ABERDEEN MIDDLE SCHOOL
HVAC SYSTEMIC RENOVATION

ADDENDUM NO. 1

DATE: March 07, 2024

PROJECT: Aberdeen Middle School
HVAC Systemic Renovation
111 Mt. Royal Avenue
Aberdeen, Maryland 21001
Gipe Project No. 23043

PH001

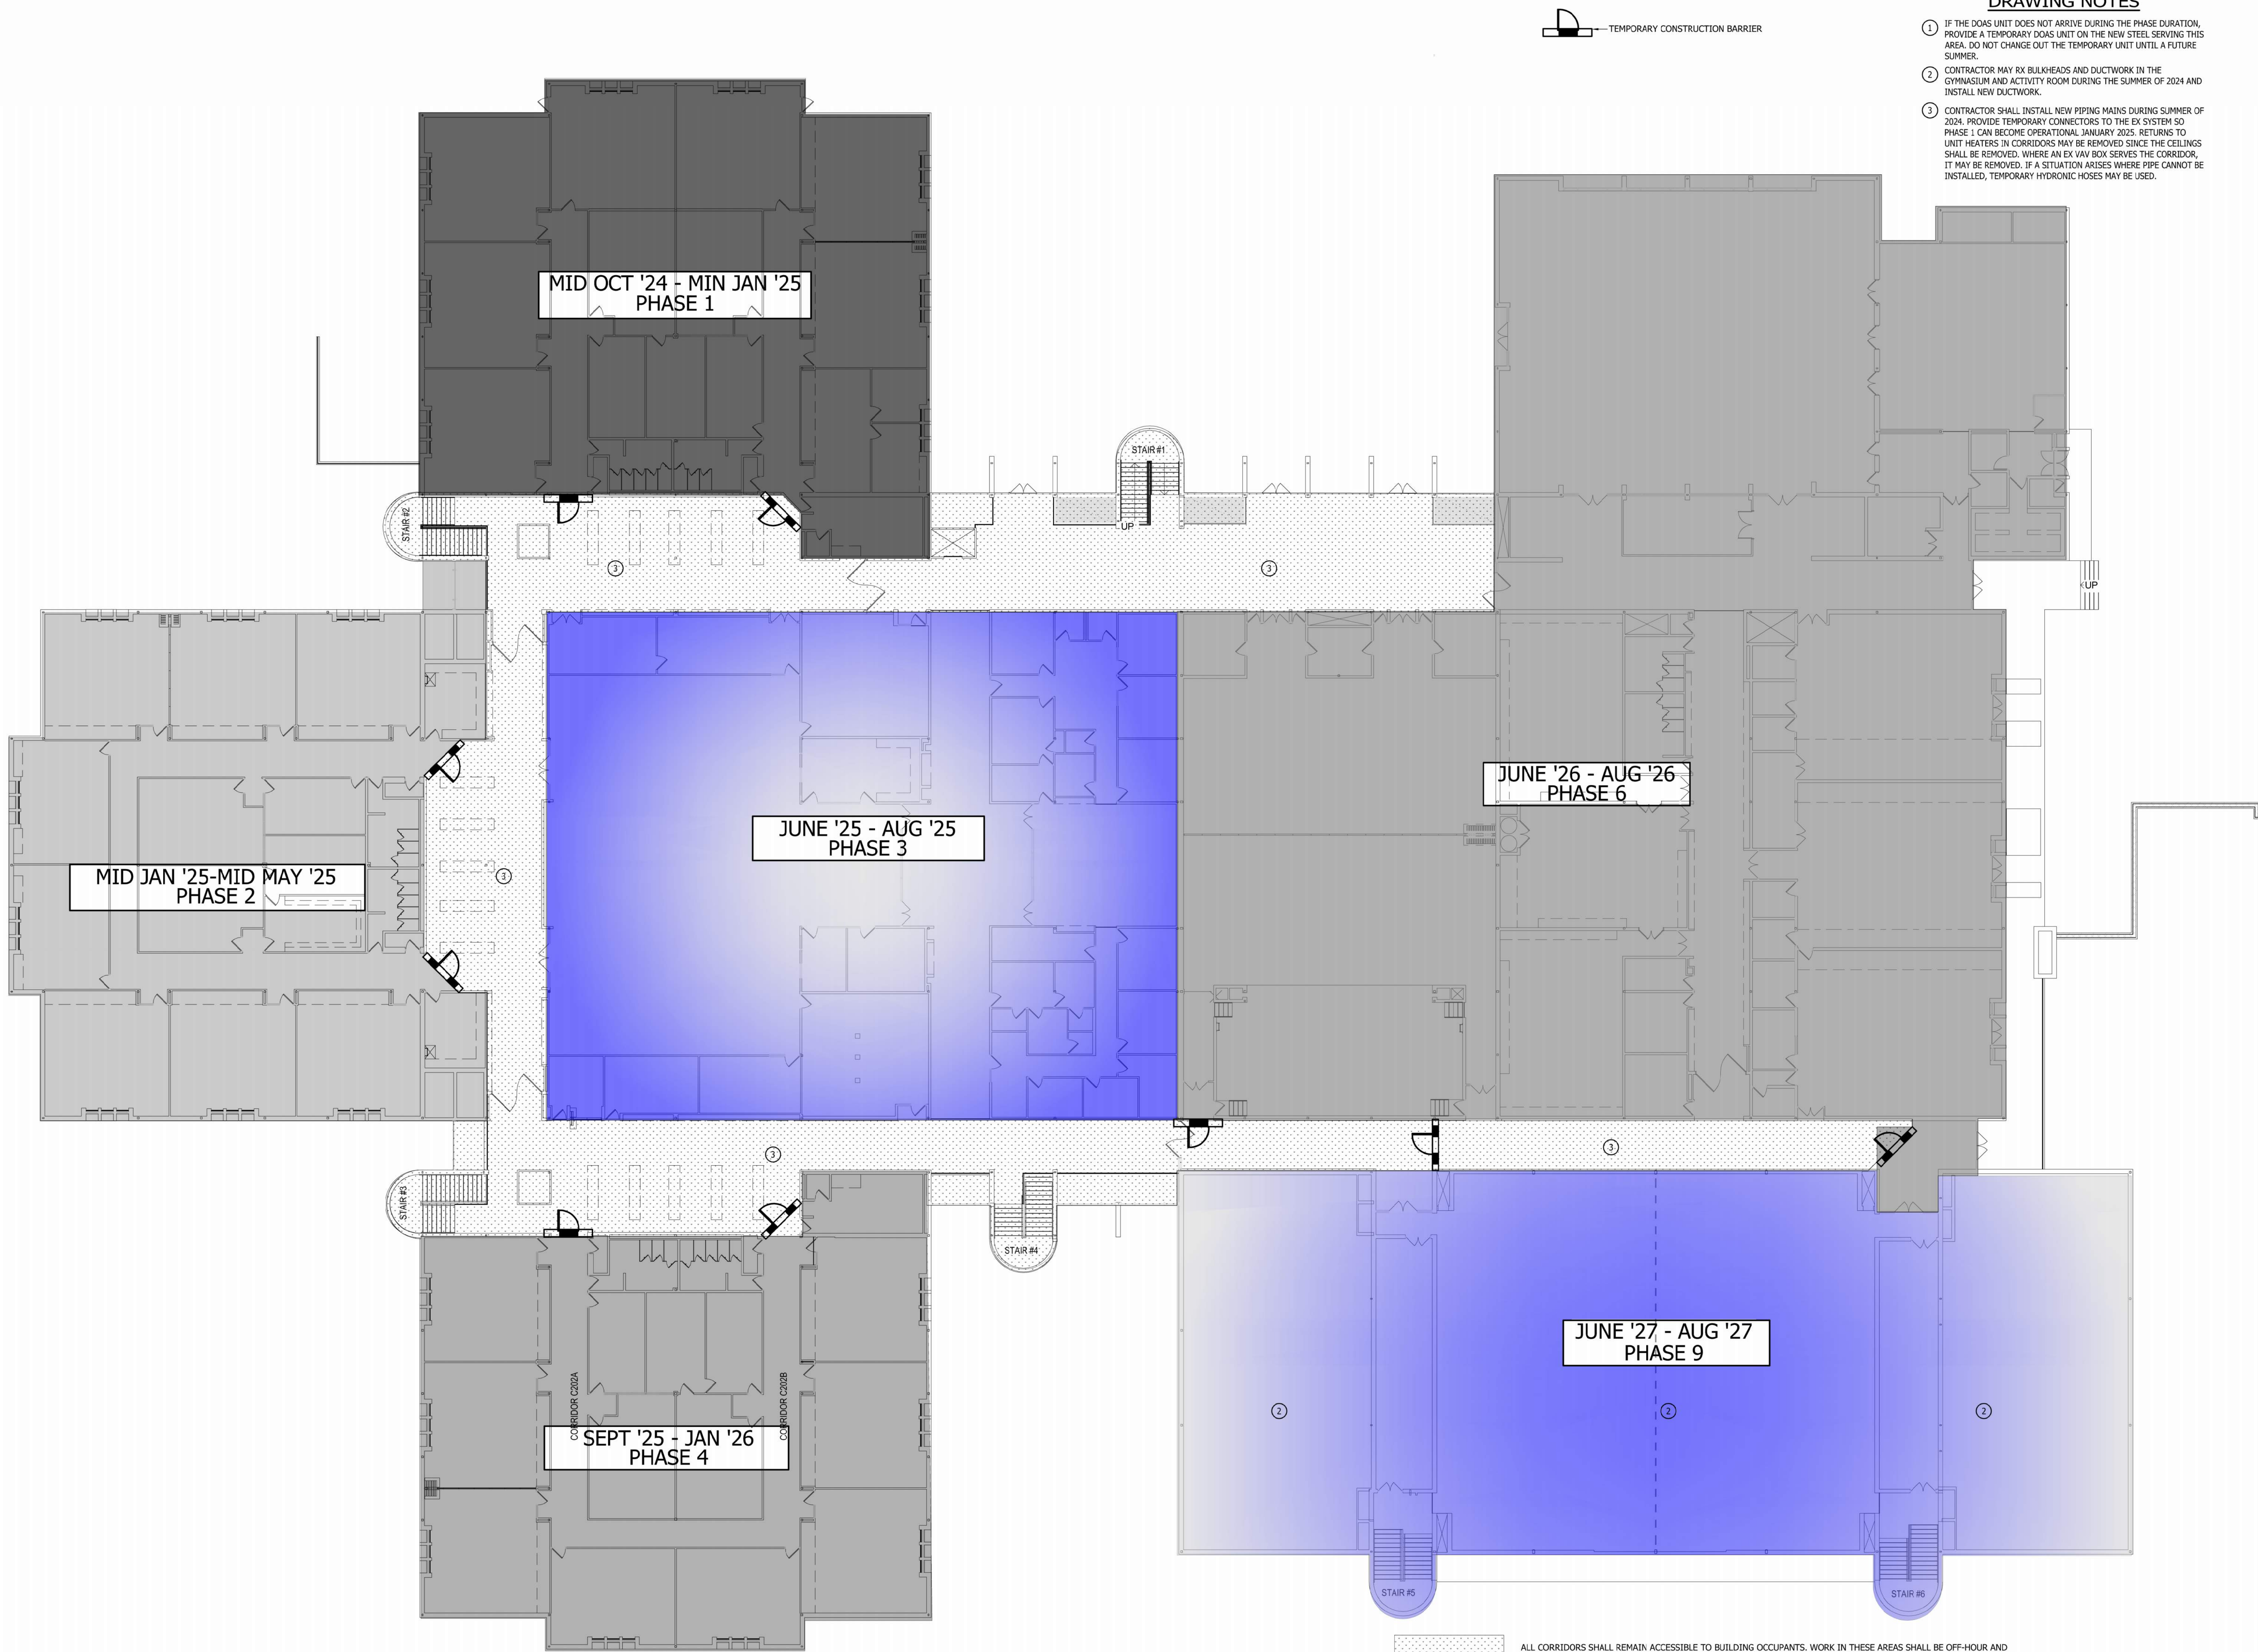
1. **PH001** – LOWER LEVEL PHASING PLAN
See attached revised drawing PH001.
2. **PH002** – UPPER LEVEL PHASING PLAN
See attached revised drawing PH001.
3. **A103** – ROOF PLAN
See attached revised drawing A103. Walking pads have been added.

LOWER LEVEL AREA C - NEW WORK

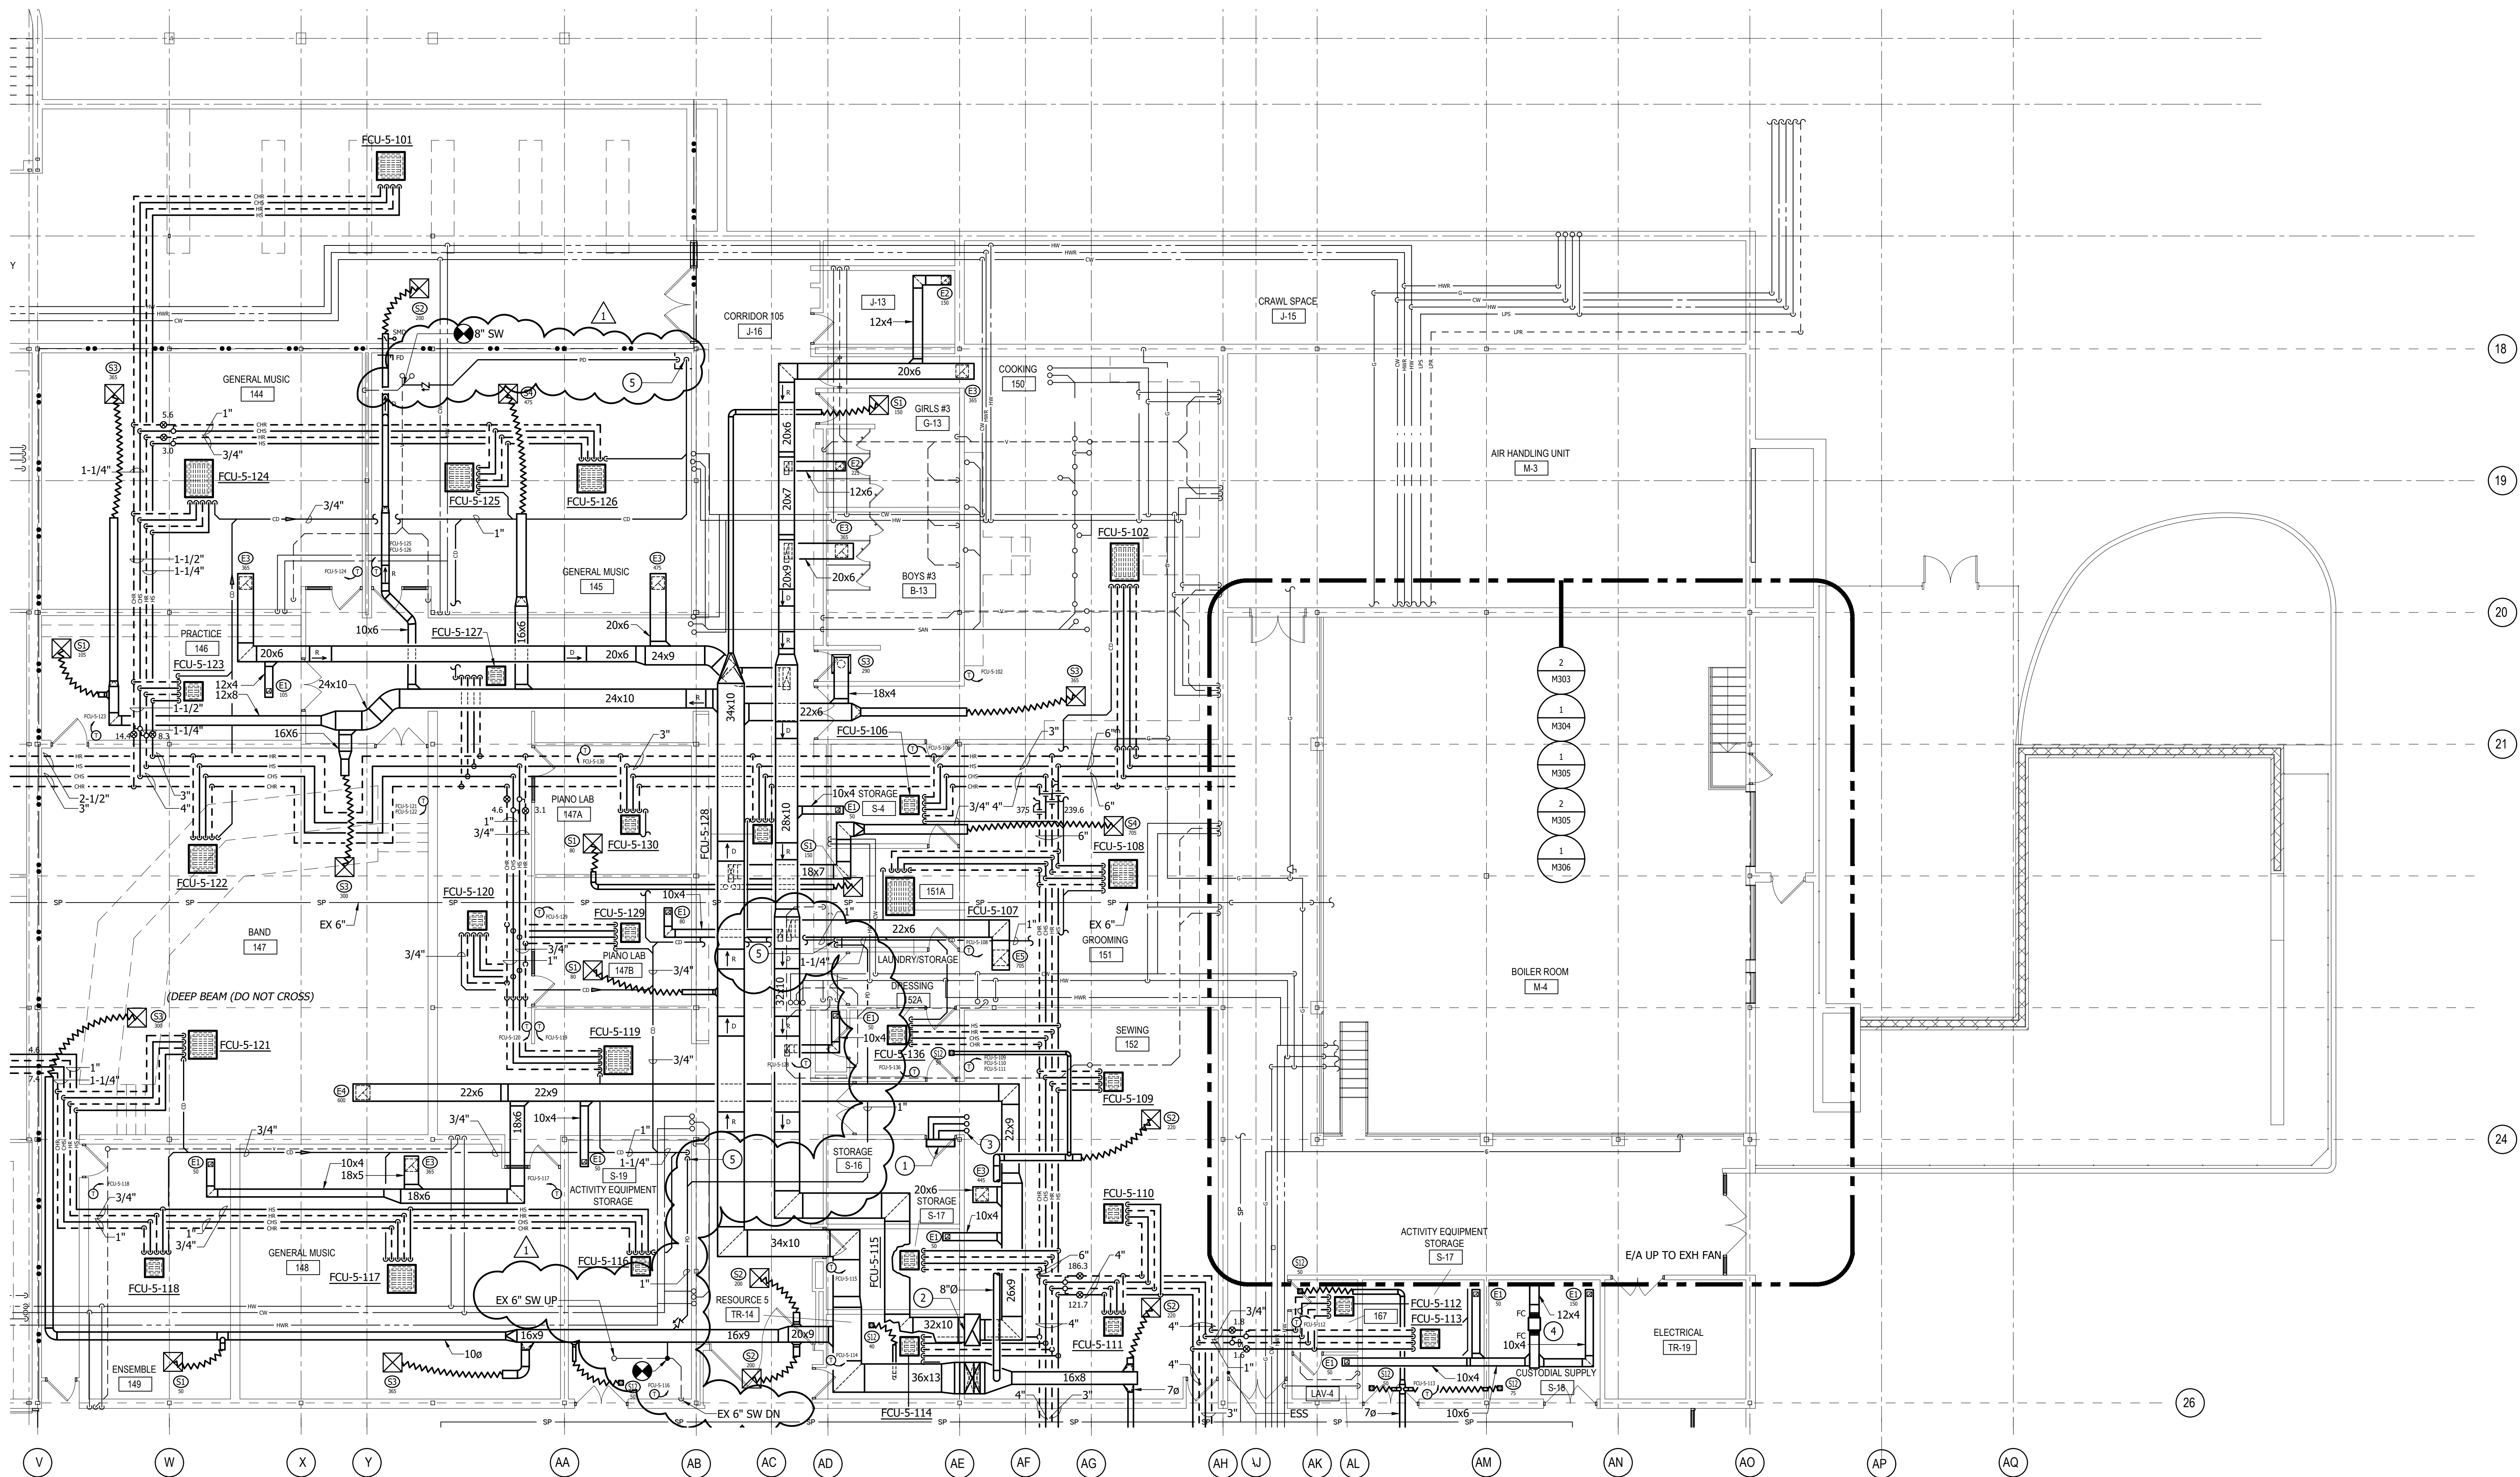
6. **M202** – LOWER LEVEL AREA C – NEW WORK
See attached revised drawing M202.
7. **M203** – LOWER LEVEL AREA E – NEW WORK
See attached revised drawing M203.

1 UPPER LEVEL PLAN AREA A - NEW WORK
SCALE: 1/8" = 1'-0"

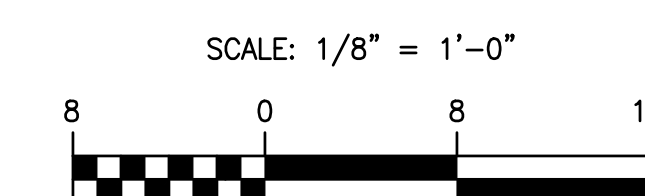
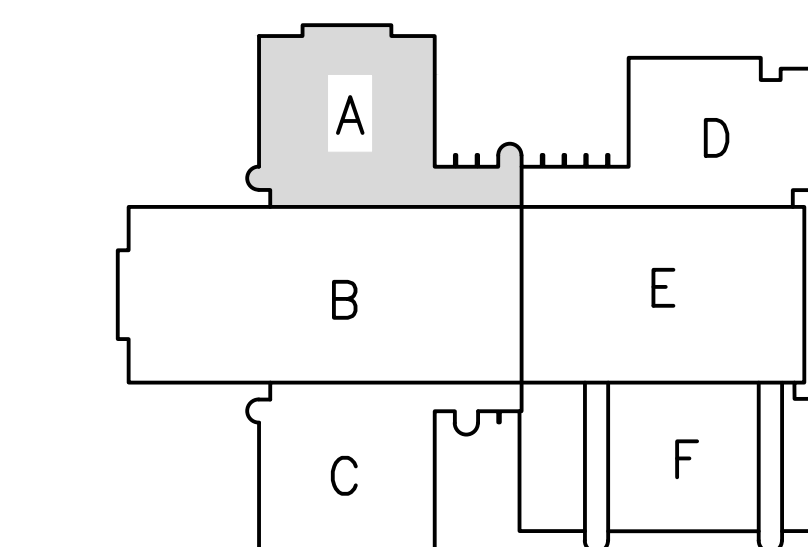
8. **M205** – UPPER LEVEL AREA A – NEW WORK
See attached revised drawing M205.
9. **M903** – SCHEDULES
Change the for all fan coil units from 120V to 277V.
